Attachment A:
Bluebird Village
Community Housing
Development
Project Plans

BLUEBIRD VILLAGE

480 N. EAST AVE.
KETCHUM, ID 83340

IN RE:)
)
Bluebird Village Community Housing Project) KETCHUM PLANNING & ZONING COMMISSION
Design Review) FINDINGS OF FACT, CONCLUSIONS OF LAW, AND
Date: August 24, 2021) DECISION
)
Application File Number: P21-063)

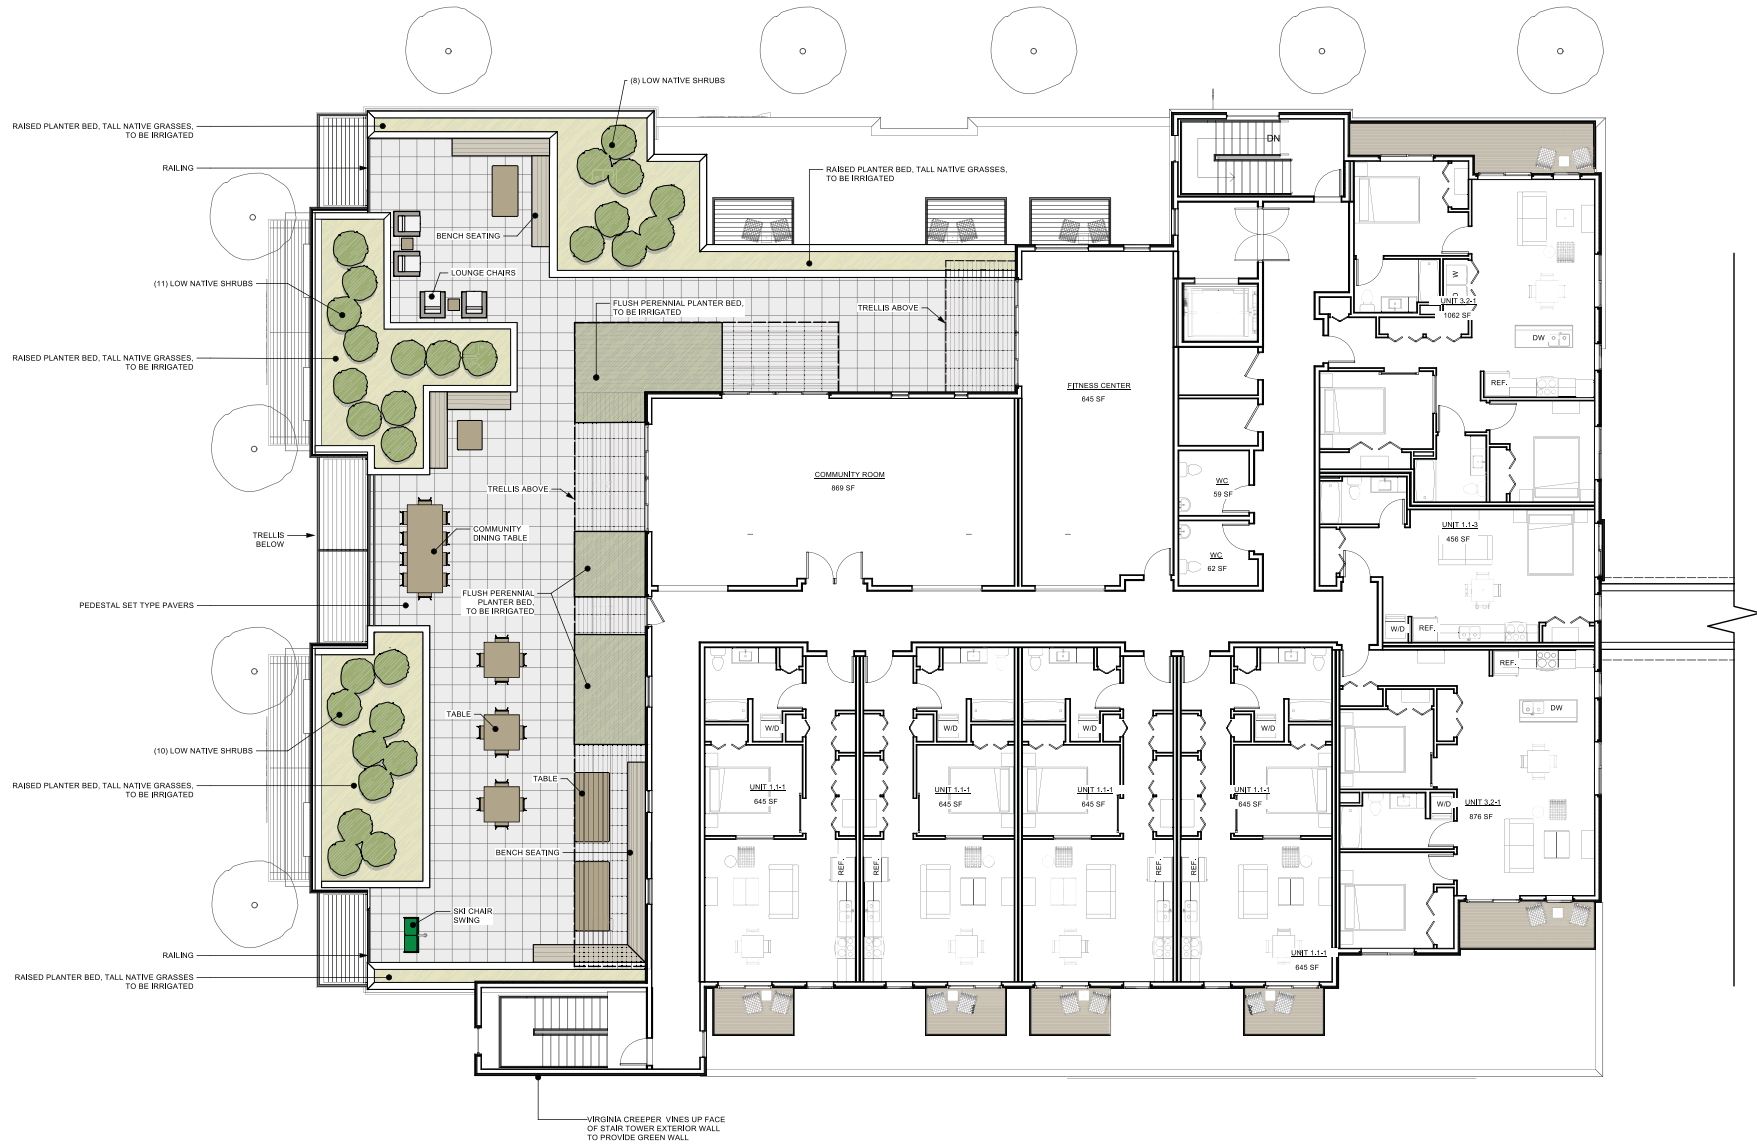
Sheet L1.0 shows 4 existing deciduous trees straddling the interior east side property line are proposed to be removed to accommodate the proposed development. The removal of these trees requires the applicant and adjacent property owner to come to an agreement on the tree removal. The applicant submitted a letter from the developer to the adjacent property into the project record that was distributed at the August 10th, 2021 Planning & Zoning Commission Meeting. In the letter, the developer offers to replace the trees being removed with new trees or other landscaping features on the adjacent neighbor's property. Condition of Approval No. 6 states that the applicant shall provide documentation this issue is resolved prior to issuance of a building permit for the project. If no resolution is forthcoming from the adjacent neighbor, documentation showing that the neighboring owner will not permit access to their property to remove those trees thereon will be considered a resolution.

<p>removed from a project site. 4 street trees are proposed along East Avenue and 9 street trees are proposed along 5th Street.</p> <p>Sheet L1.0 shows 4 existing deciduous trees along the interior east side property line; the 2 on the project site are proposed to be removed to accommodate the proposed development and the 2 on the adjoining property will be removed and replaced if the adjoining landowner agrees. The removal of these trees requires the applicant and adjacent property owner to come to an agreement on the tree removal. The applicant submitted a letter from the developer to the adjacent property into the project record that was distributed at the August 10th, 2021 Planning & Zoning Commission Meeting. In the letter, the developer offers to replace the trees being removed with new trees or other landscaping features on the adjacent neighbor's property. Condition of Approval No. 6 states that the applicant shall provide documentation this issue is resolved prior to issuance of a building permit for the project. If no resolution is forthcoming from the adjacent neighbor, documentation showing that the neighboring owner will not permit access to their property to remove those trees thereon will be considered a resolution.</p> <p>The landscape plan shows an existing tree located to the south of Building A along 5th Street on the adjacent property located at 440 N East Avenue proposed to be preserved throughout the duration of construction. Condition of Approval No. 7 specifies that the applicant shall comply with the tree preservation plan prepared by Alpine Tree Services dated July 16th, 2021 and requires that all recommendations described in the tree preservation plan be incorporated into the construction management plan submitted with the Building Permit application for the project.</p>

6. Sheet L1.0 shows 4 existing deciduous trees along the interior east side property line; the 2 on the project site are proposed to be removed to accommodate the proposed development and the 2 on the adjoining property will be removed and replaced if the adjoining landowner agrees. The applicant shall provide documentation the tree removal issue is resolved prior to issuance of a Building Permit for the project. If no resolution is forthcoming from the adjacent neighbor, documentation showing that the neighboring owner will not permit access to their property to remove those trees thereon will be considered a resolution.

PROPOSED MASTER SIGNAGE PLAN

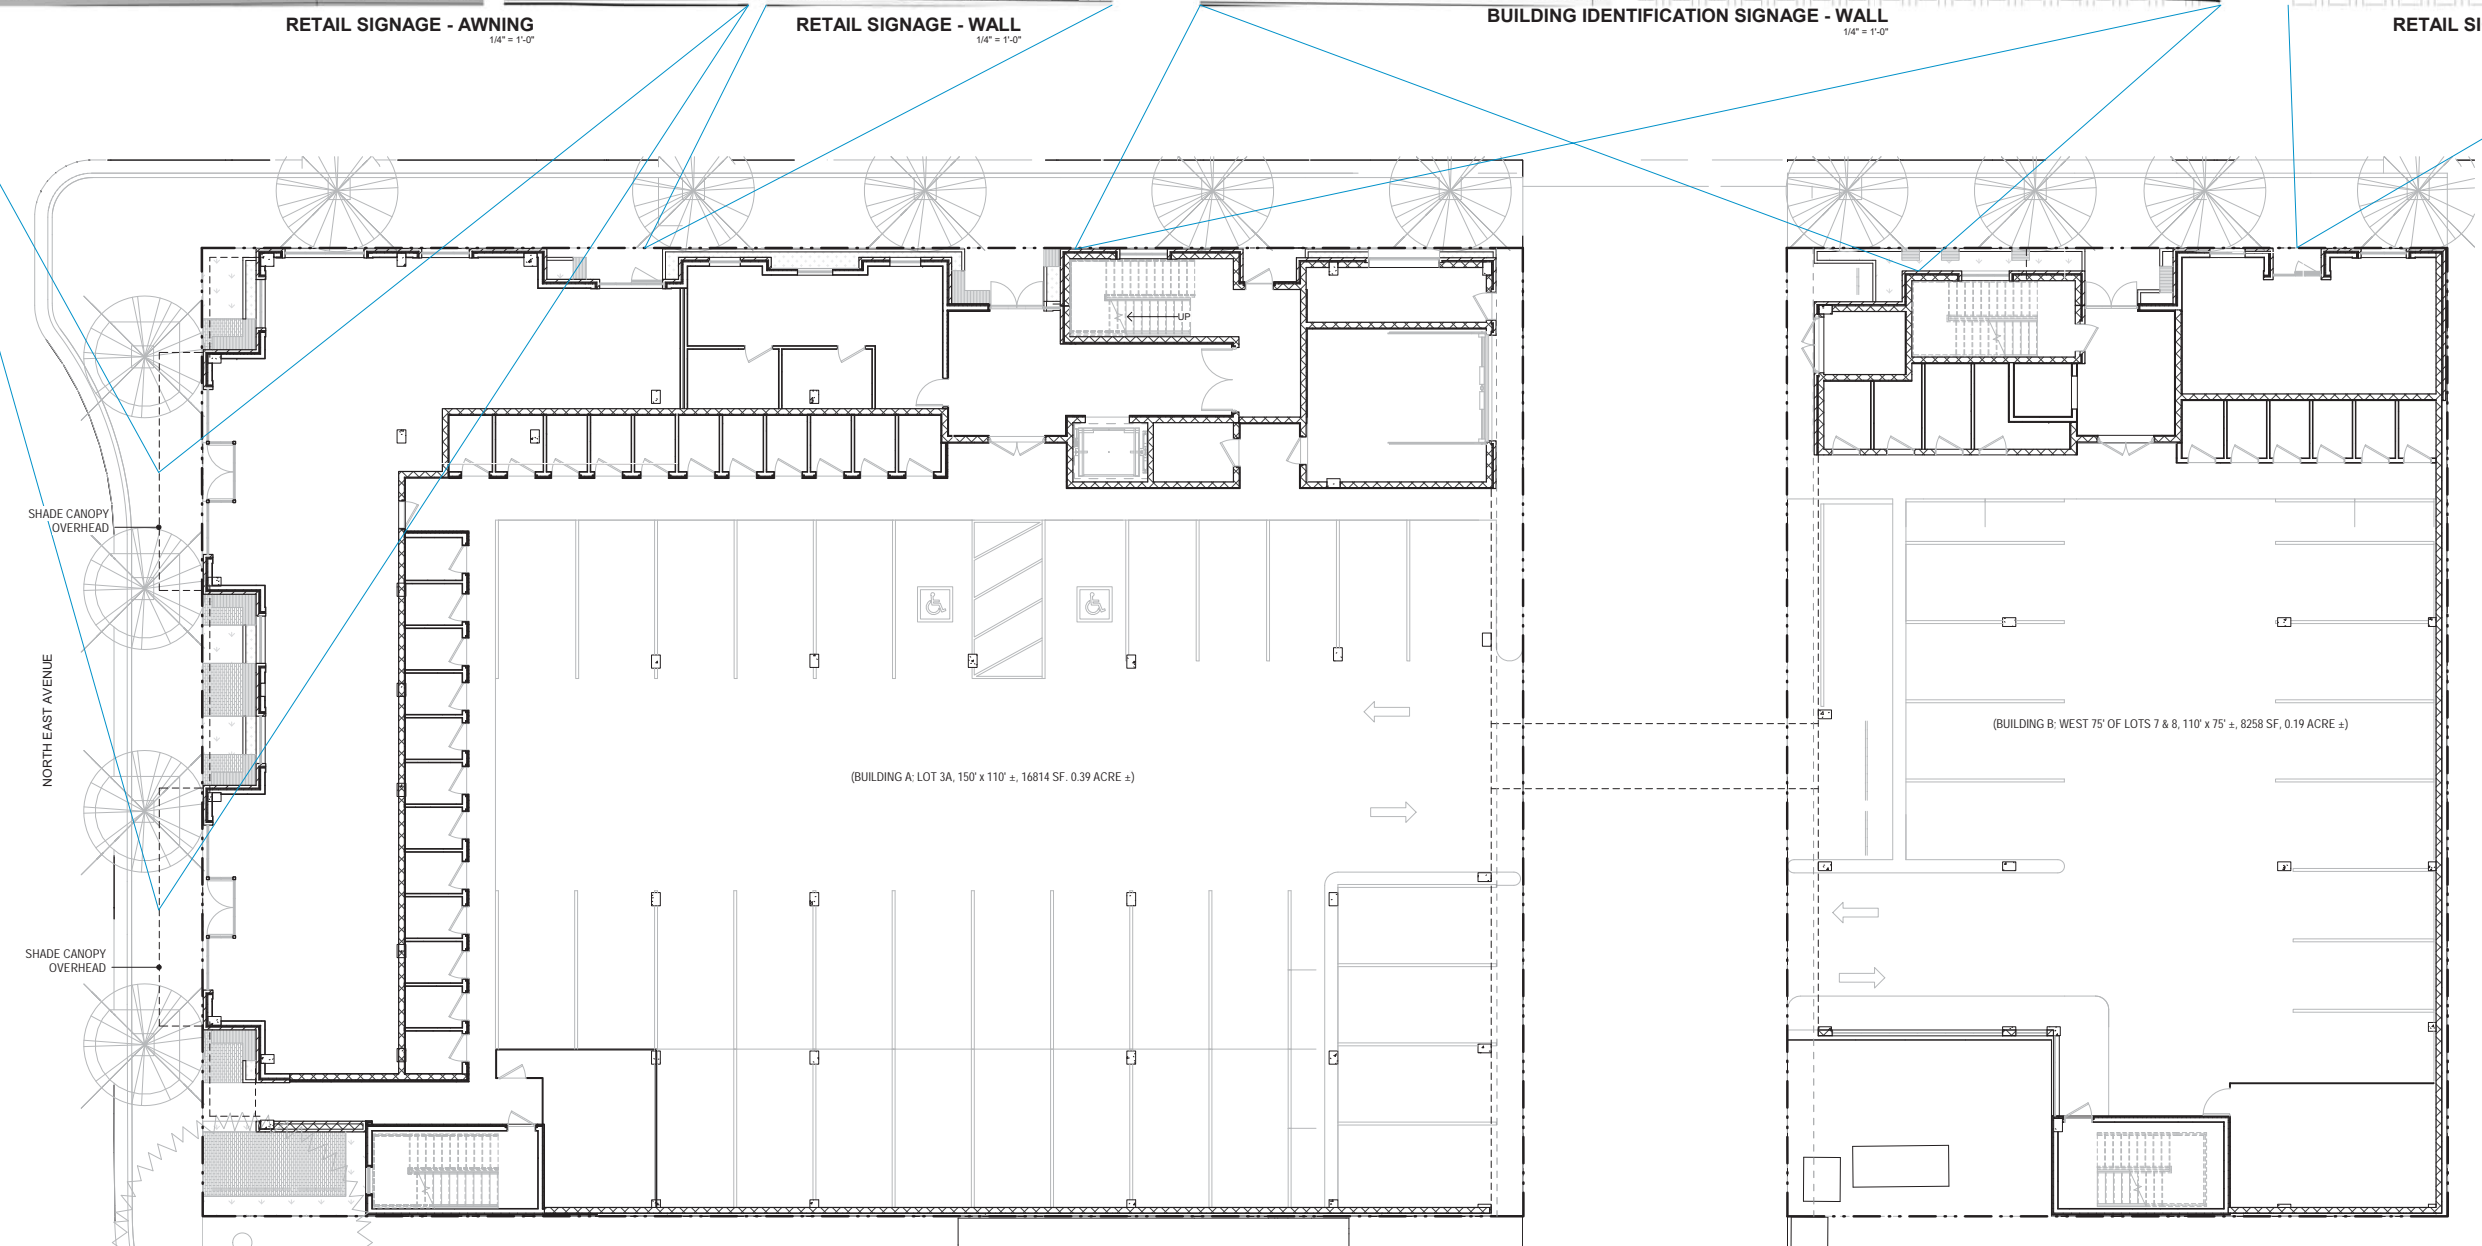
The project's master signage plan is indicated on Sheet AA6.01 of the project plans attached as Exhibit A to the August 10th Staff Report. The development's signage includes both awning and wall signs. The face of all signs will be black, oxidized-carbon steel. The copy on the signs is powder-coated blue. The blue animates the signage echoing the blue panels on the 5th Street facade. Separate sign permits will be required for all new signs prior to installation (Ketchum Municipal Code §17.127.030.B).
